Minutes of Meeting

Local Traffic Committee Meeting

BYRON
SHIRE
COUNCIL

MINUTES OF THE LOCAL TRAFFIC COMMITTEE MEETING HELD ON TUESDAY, 16 MAY 2023

Figure 2: Bayshore Lane formation

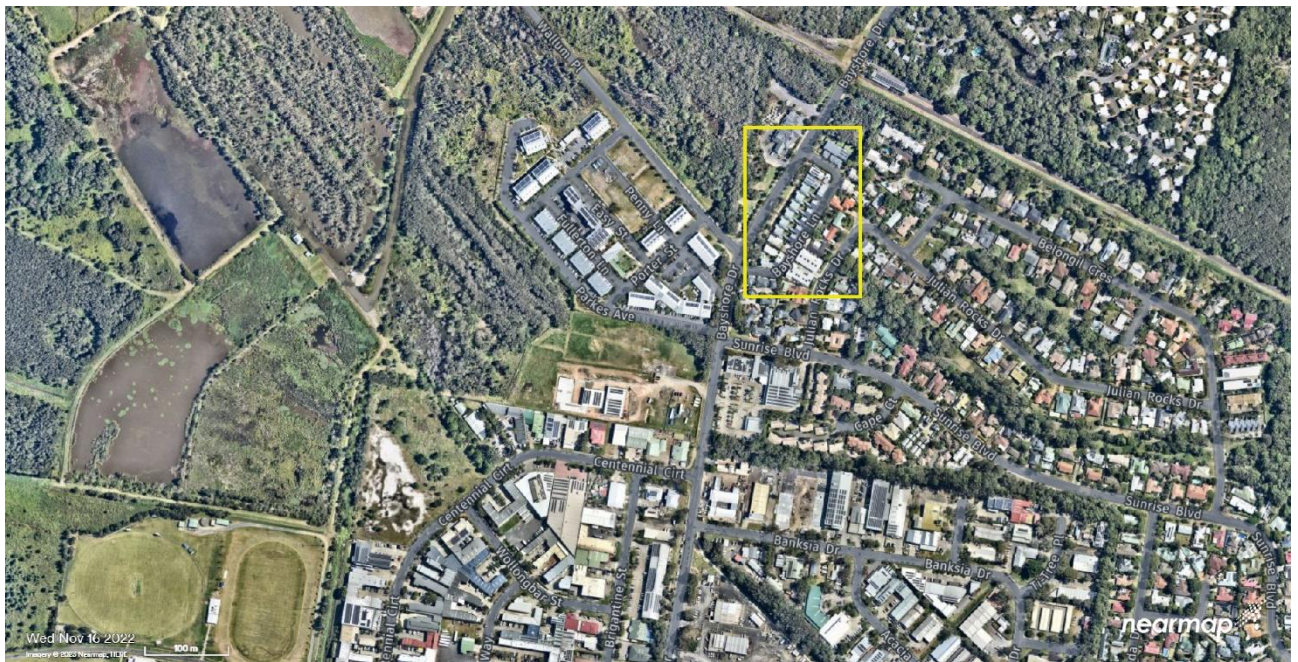
- Given the clear mandate from residents of Bayshore Lane and the minimal traffic impacts the one-way treatment seems appropriate
- The proposed signage is in line with current standards
- From a road safety perspective the thick vegetation on the road reserve should be removed rather than cut back to reduce the risk of an accident between pedestrian/cyclist and motorists at the crossing points of Bayshore Dr/Bayshore Lane.

That the Local Traffic Committee endorse the implementation of one-way traffic within Bayshore Lane, Byron Bay (northbound) if community and stakeholder engagement does not raise any reasons not to proceed.

Figure 2: Optimal zone EV charging mapping, NSW Climate and Energy Action Master Plan

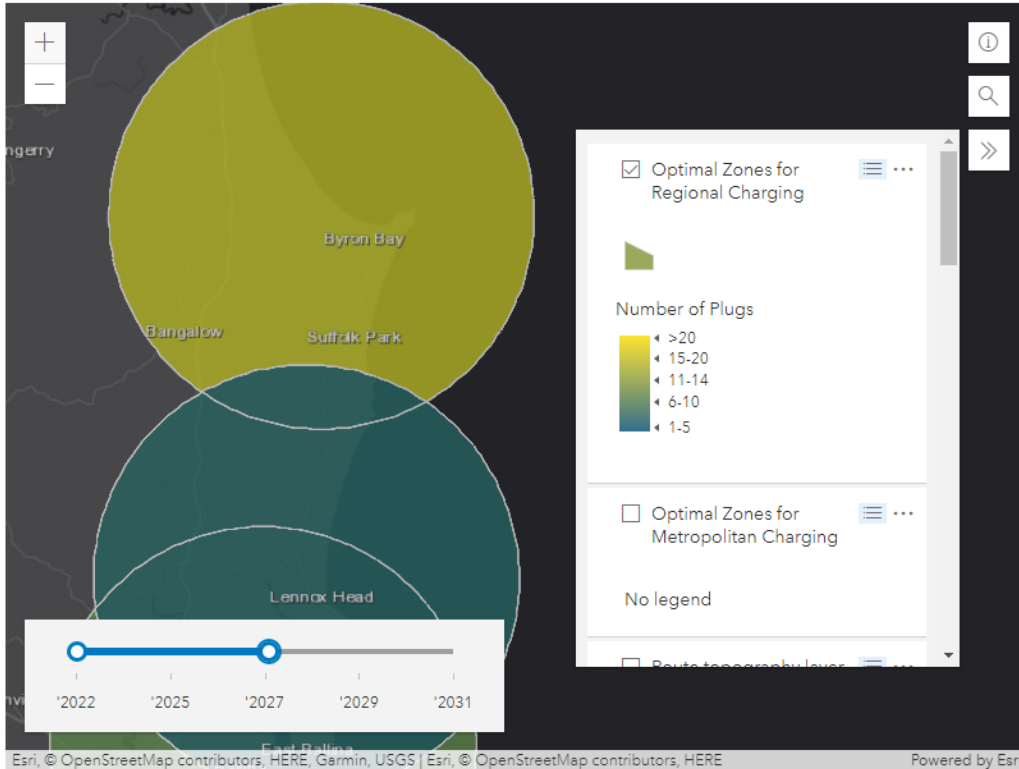
TfNSW comments received via email (E2023/48979):
The proposed signage is in line with current standards

That the Local Traffic Committee endorse parking restrictions to support two Electric Vehicle car parking spaces in Byron Bay Town Central, two of the five locations within Attachment 1 (E2023/46707) as part of the Essential Energy EVX pole mounted charger trial.
